Additions and Renovations
Platt Technical High School
Milford, CT

ADDENDUM NO. 3

August 2, 2019

date: 05/24/2019
scale: 3" = 1'-0"
drawn by: [blank]
approved by: [blank]
drawing no.: **A6-3-15**

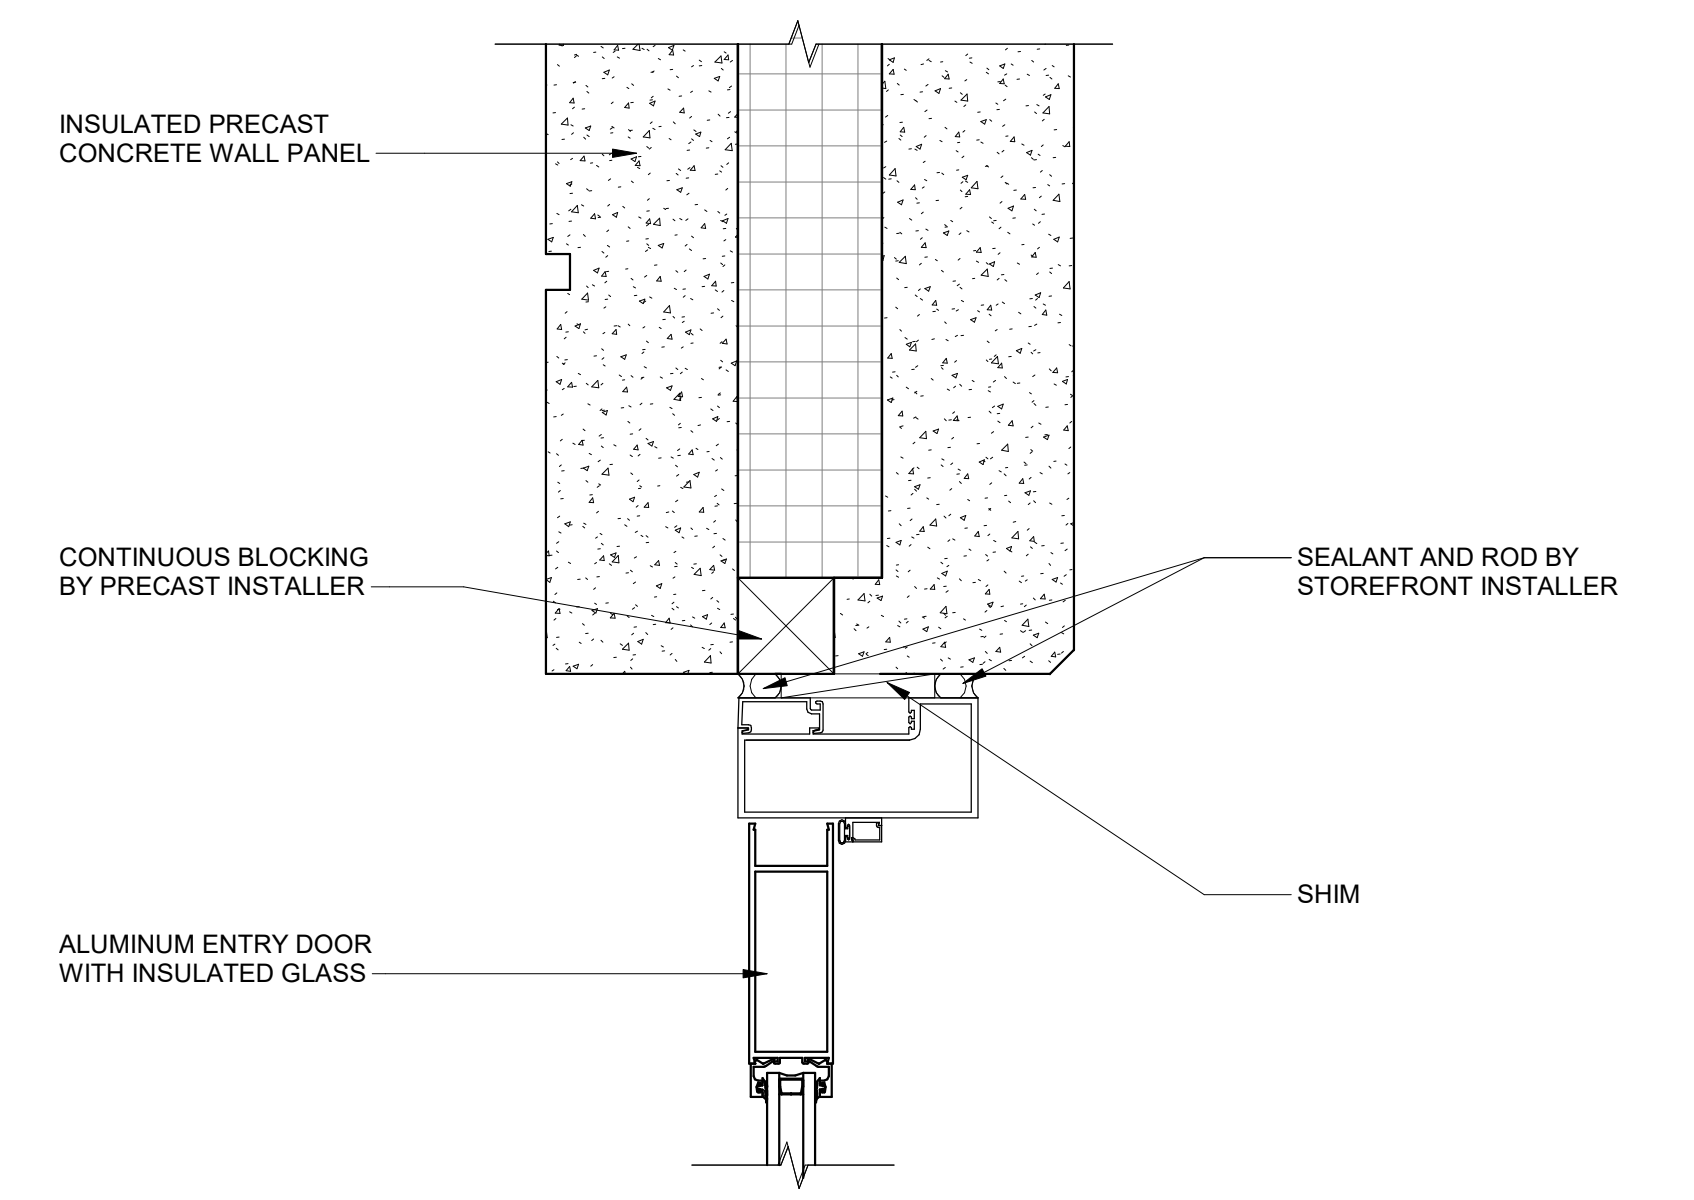
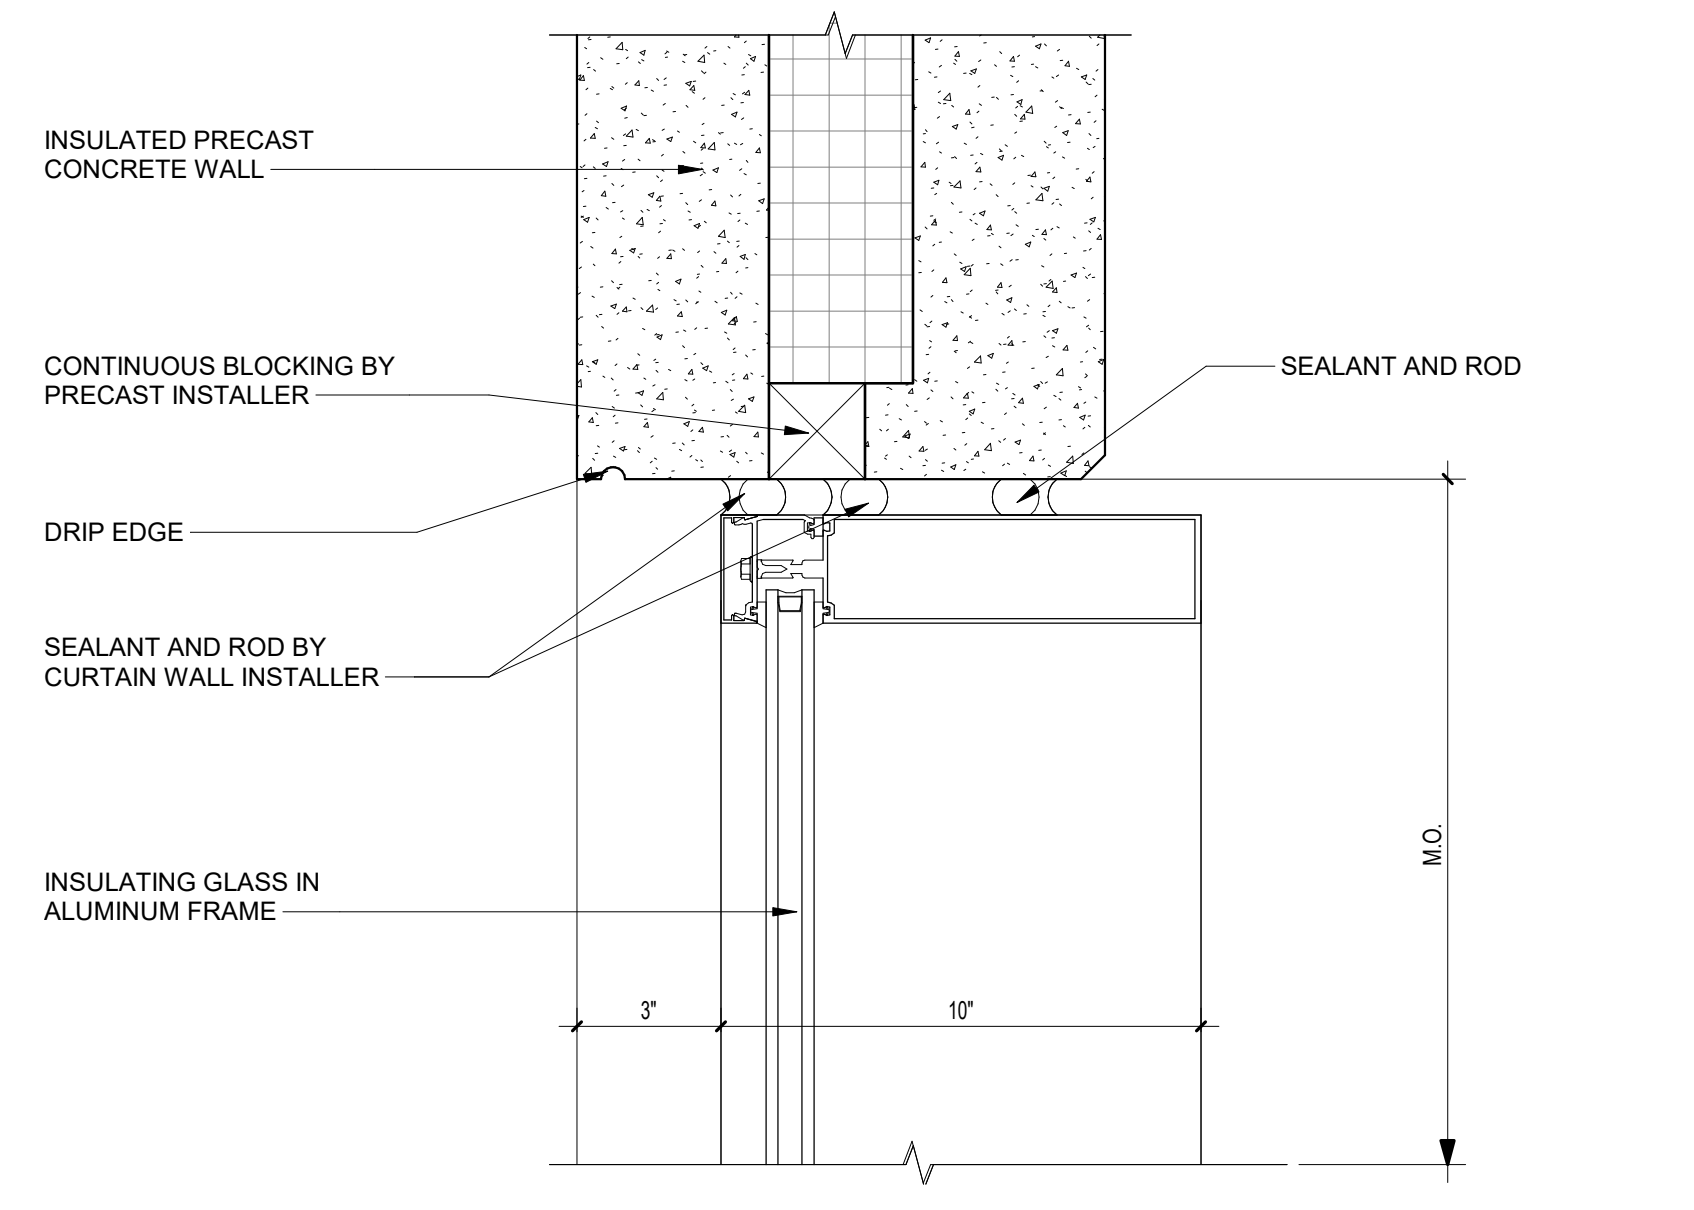
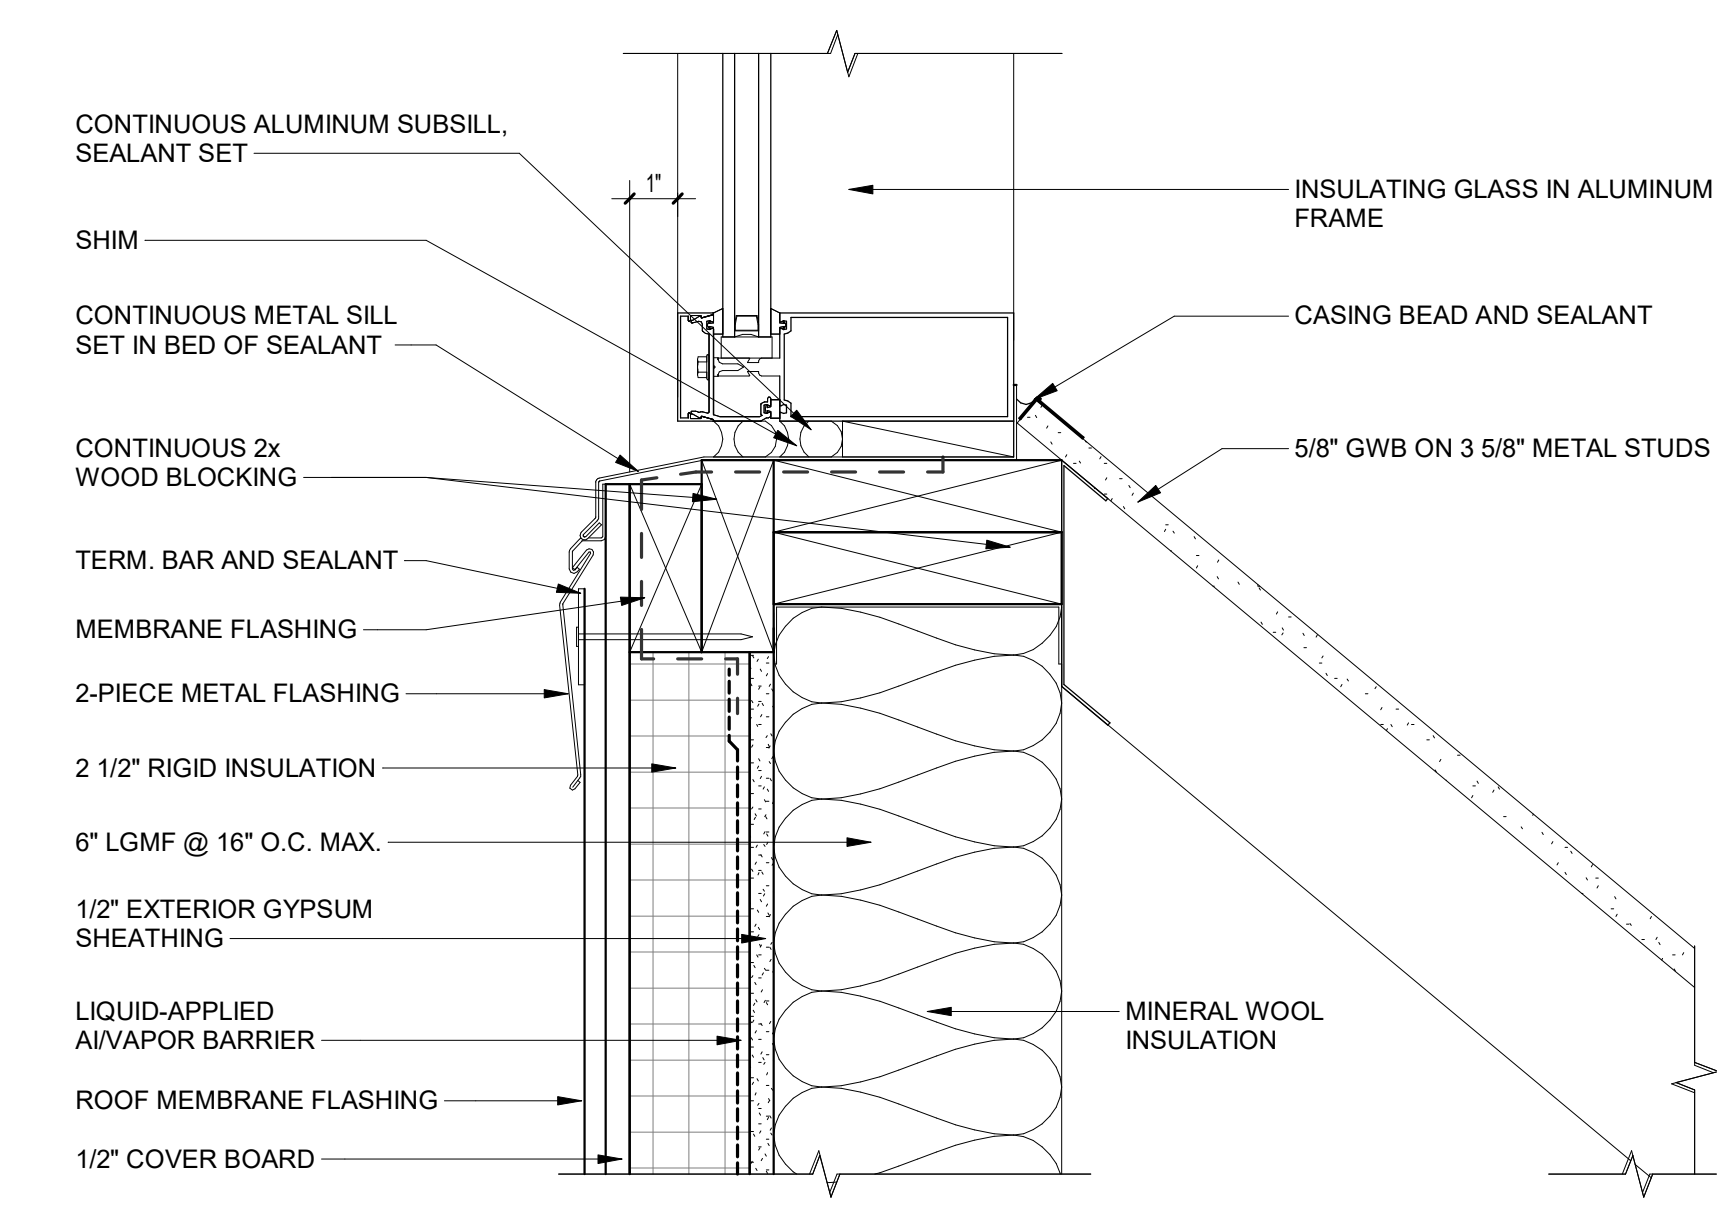
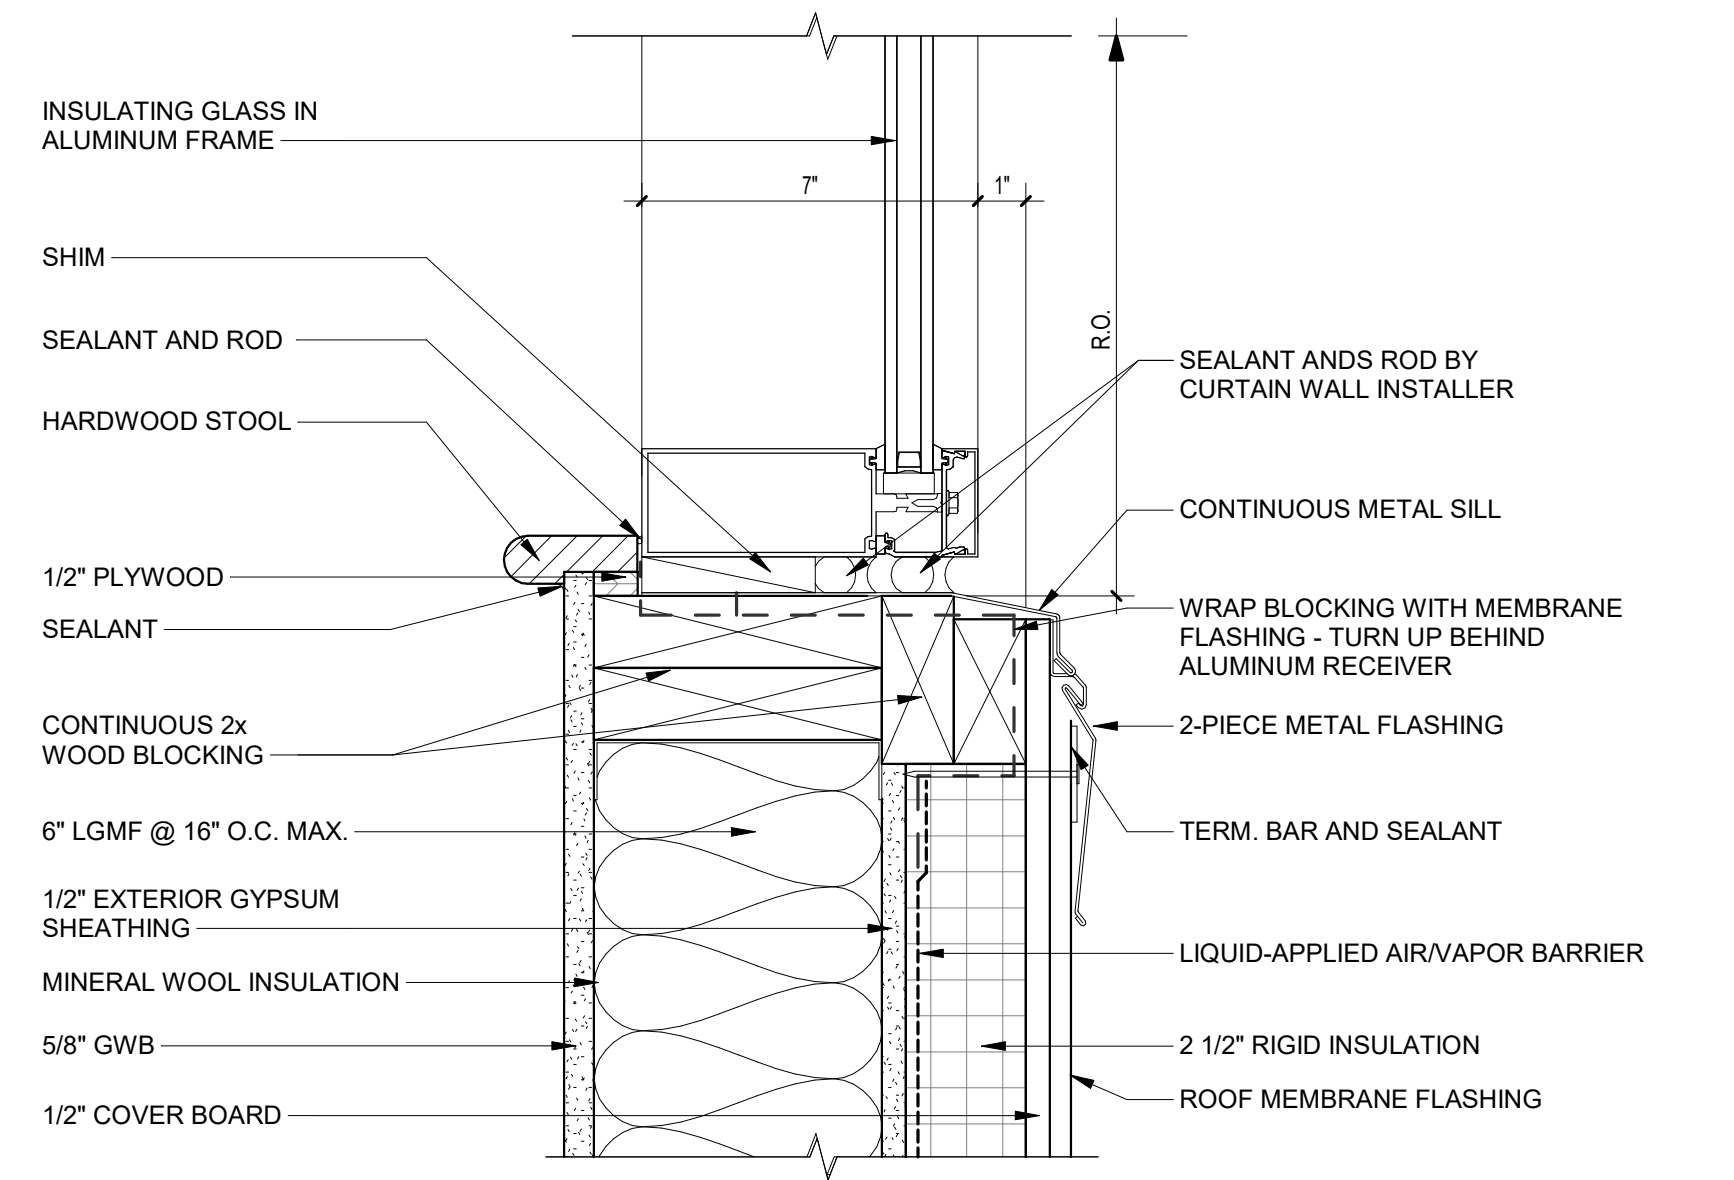
- ADD 3-069 DRAWING A6-3-15 – CURTAIN WALL AND EXTERIOR STOREFRONT DETAILS**
(previously drawing titled Exterior Storefront Details)
Revision RA3-7:
Detail 1 through 15: Revised detail to reflect frame type changes.
